DART AEROSPACE LTD		Work Order:	B3832
Description: Crosstube Assembly (412 High Aft)		Part Number:	D412-664-243
Inspection Dwg: D412-664-243 Rev: E		Page 1 of 1

DRAWING NO. D412-664-243	TITLE CROSSTUBE ASSEMBLY (412 HI AFT)	REV. E	DART AEROSPACE LTD ENGINEERING ORDER		D.E.O. NO. D412-664-243-E-1	SHEET NO. SHEET 1 OF 2	SCALE NTS
DRAWN	CHECKED <i>MP</i>	MFG. APPR. <i>E</i>	APPROVED <i>MP</i>		DE APPR. <i>MP</i>		
DATE 11.03.31	DATE 11/03/31	DATE 11.03.31	DATE 11/03/31		DATE 11.03.31

REMOVED ABRASION STRIP IN FAVOR OF A THIN LAYER OF PROSEAL 890.

REPLACE MAGNOBOND WITH 3M DP460 SCOTCH-WELD EPOXY ADHESIVE

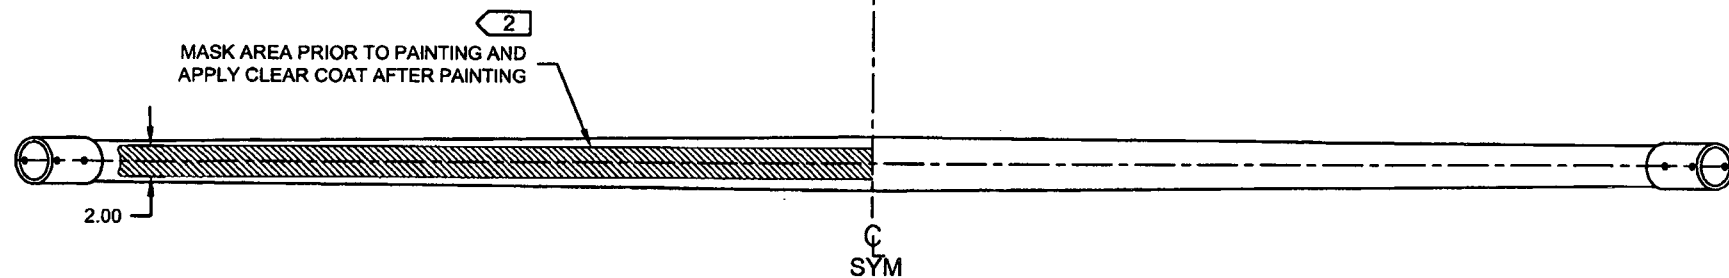
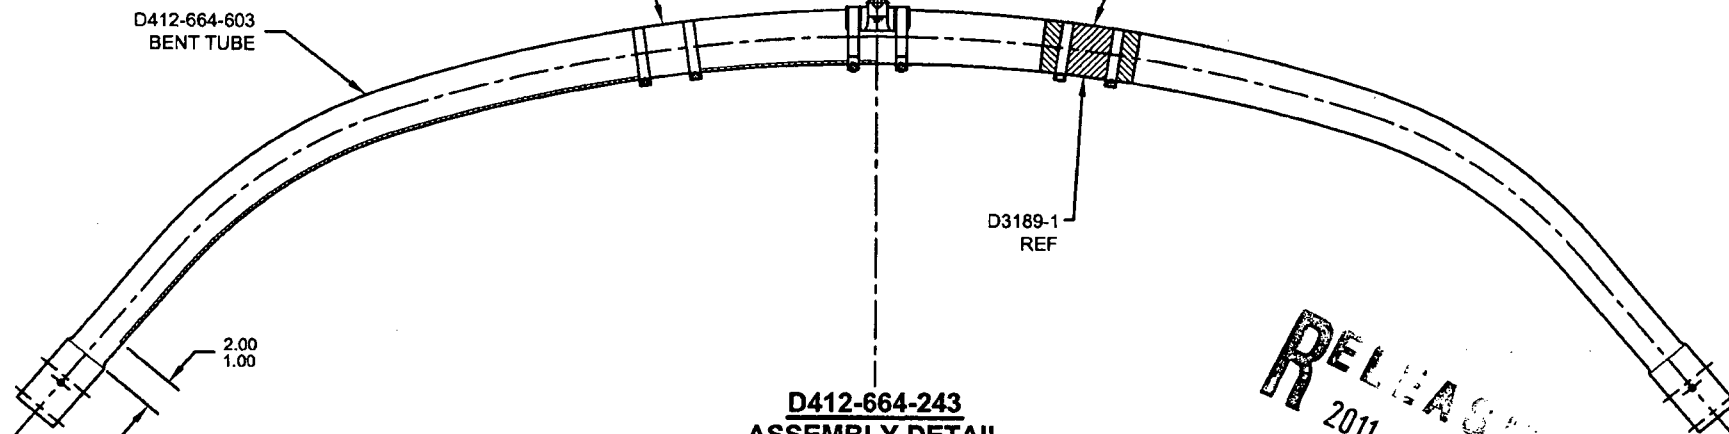
IS:

D3189-1 CHAFING SHIELD (1, INSTALLED OVER PROSEAL 890)
MS21920-28 CLAMP, 2X
2 PL

WAS:

D2856-600-1009 ABRASION STRIP
D3189-1 CHAFING SHIELD (1, INSTALLED OVER ABRASION STRIP)
MS21920-28 CLAMP, 2X
2 PL
